knitter-switch

Product Change Notification

Affected products: TMSE 10 J-RA

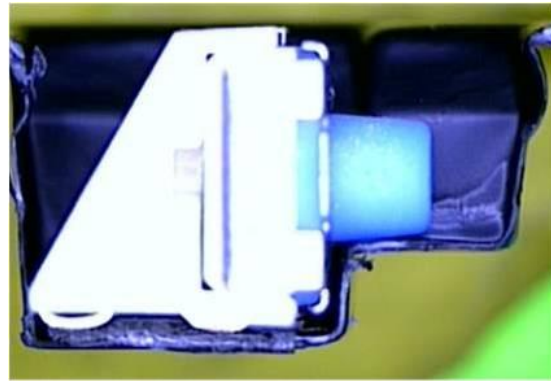
In the course of continuously product improvement the design of the carrier tape pockets is changed. This will support the stable position of the component during pick&place by avoid of tilting of the component in the pocket.

Old: component may tilt back and forth

New: No tilting by support of knob

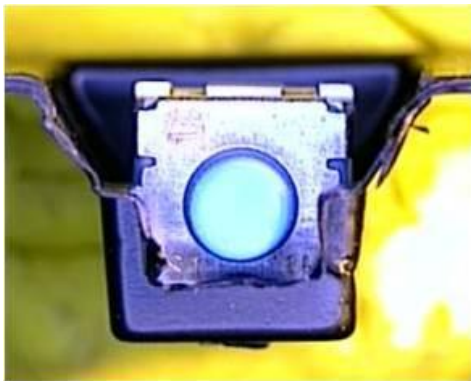
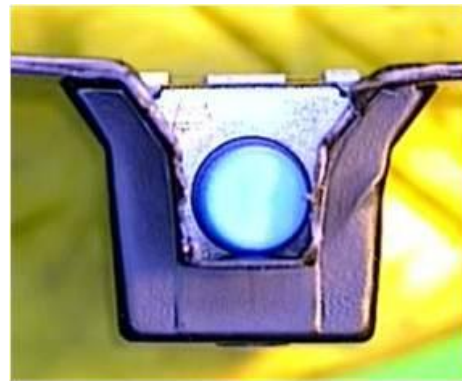
Old: component may tumble from left to right

New: No tumbling by tighter pocket
